Office Action Summary	Application No. 10/828,843	Applicant(s) PERKINS ET AL.	
	Examiner /Robert James Popovics/	Art Unit 1797

DETAILED ACTION

Claim Rejections - 35 USC § 103

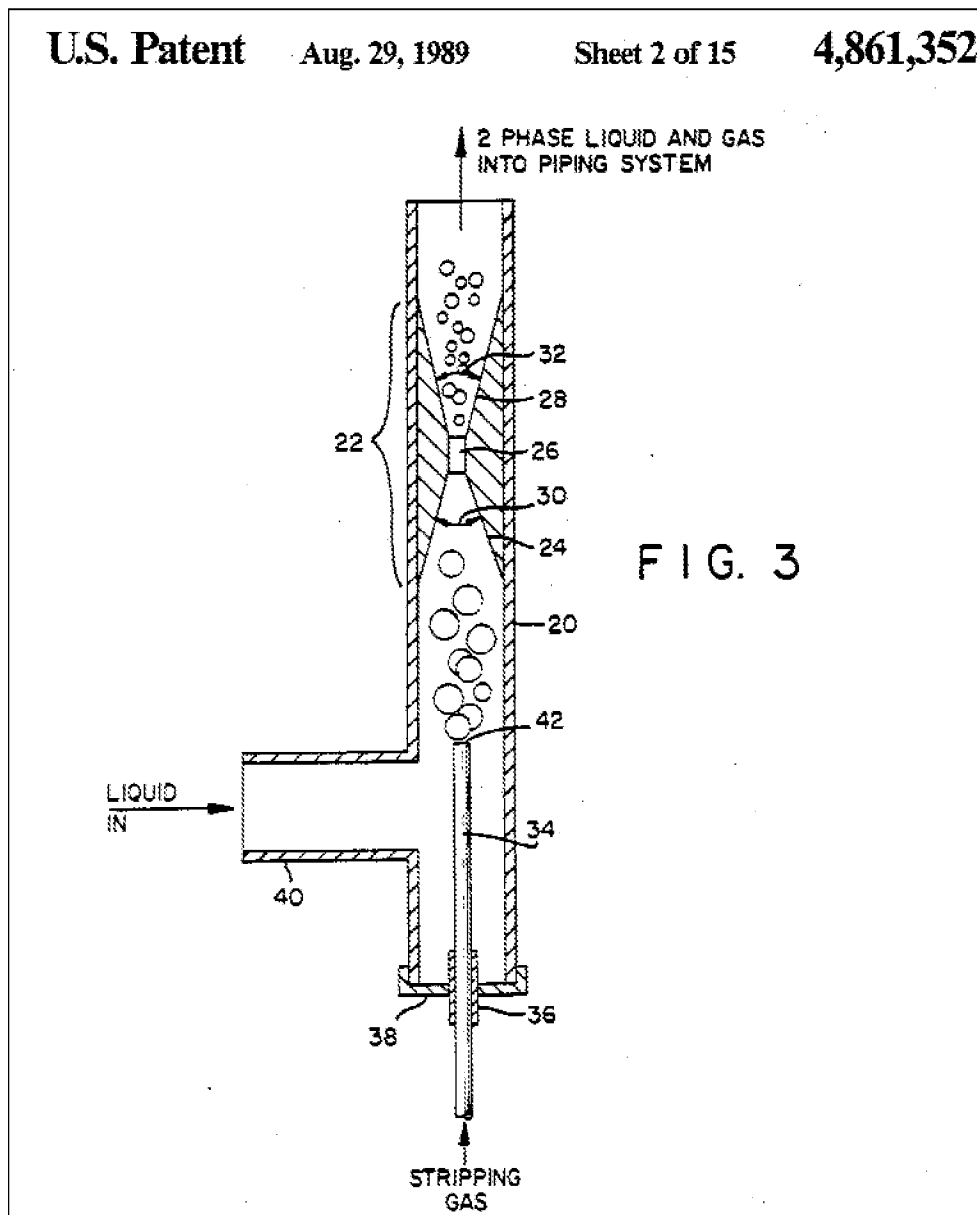
Claims 1, 3-12, 14 and 16-33 are rejected under 35 U.S.C. 103(a) as being unpatentable over the combined teachings of **Cheng (US 4,861,352)** and **AAPA (Applicant's Admitted Prior Art)**. **Cheng** discloses an inline stripper:

Cheng does not appear to expressly disclose ***“establishing a well”*** as recited in independent claim 1, or ***“at least one well extending from the ground surface to a downhole location,”*** as recited in independent claim 12. **AAPA**

teaches that those structures fore and aft the claimed inline stripper are conventional or well known to those skilled in the art.

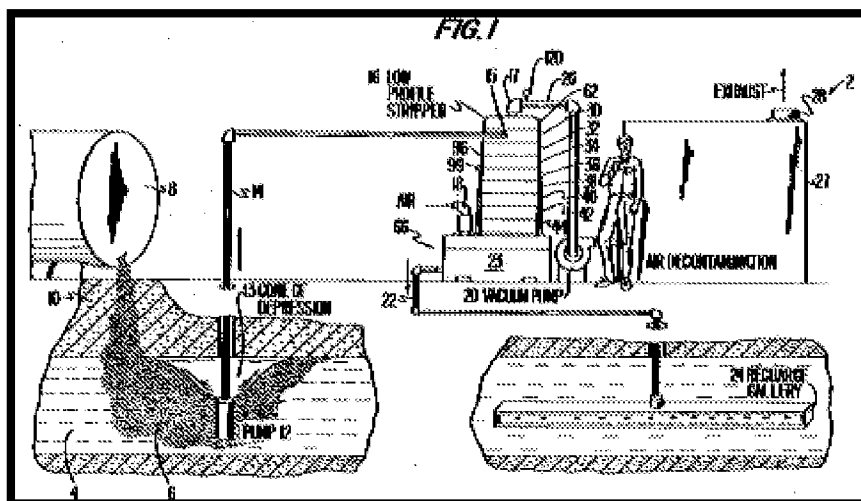
Those of ordinary skill are believed to be well-versed in the use of the above and other similar subterranean groundwater/ vapor removal technologies in connection with which the invention may be used.

nants. Determination of sizing, depth, and all other relevant parameters in connection with construction and proper operation of the well 12 for withdrawing contaminated groundwater is readily accomplished by any person of ordinary skill in the art. For illustration purposes only for

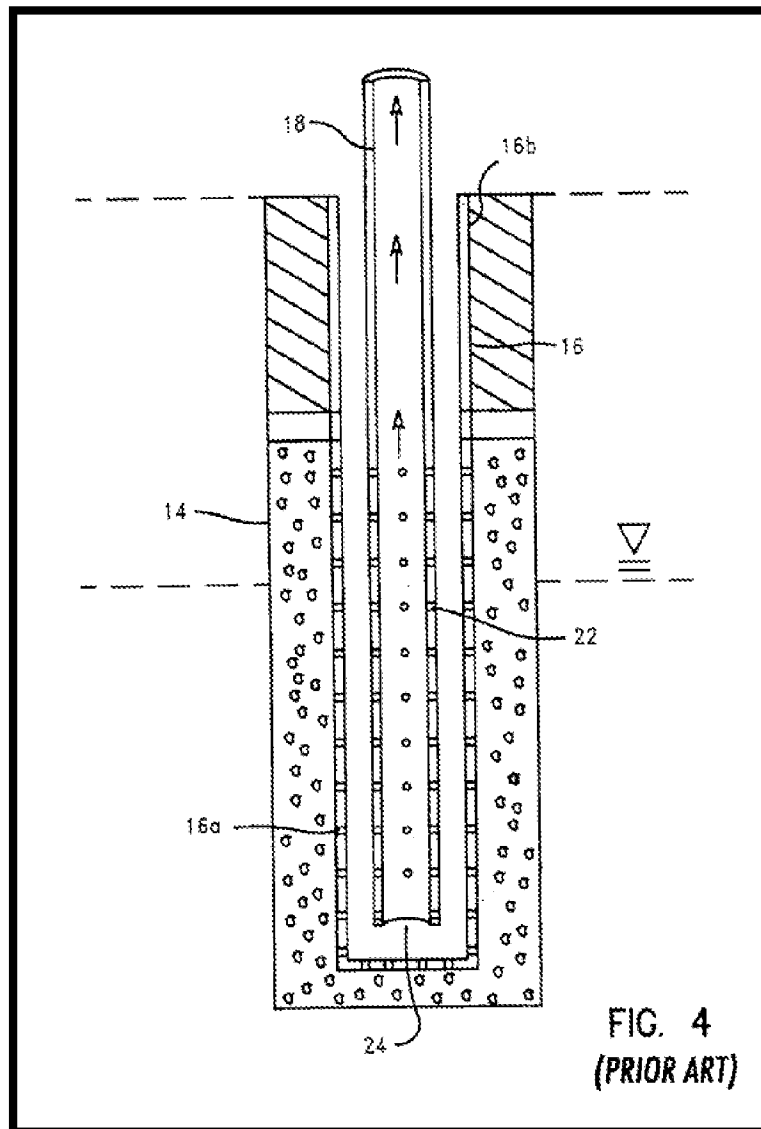
Then Applicants argue:

Nothing in the cited art would have prompted one of ordinary skill to combine Cheng's venturi with the remaining cited art in the manner of Applicants' claimed system.

The Cheng reference clearly teaches the use a venturi to strip a gas from a liquid. This is well known in the art. The hypothetical person having ordinary skill in the art is charged with all that is known in the art. Accordingly, the hypothetical person having ordinary skill in the art would have known of such venturi type stripping devices. The substitution of one known stripping device for another is seen to be exceedingly obvious, in the same way that an auto mechanic would know that a car could be jacked up with a floor jack, a scissor jack, a hydraulic bottle jack, or a bumper jack.
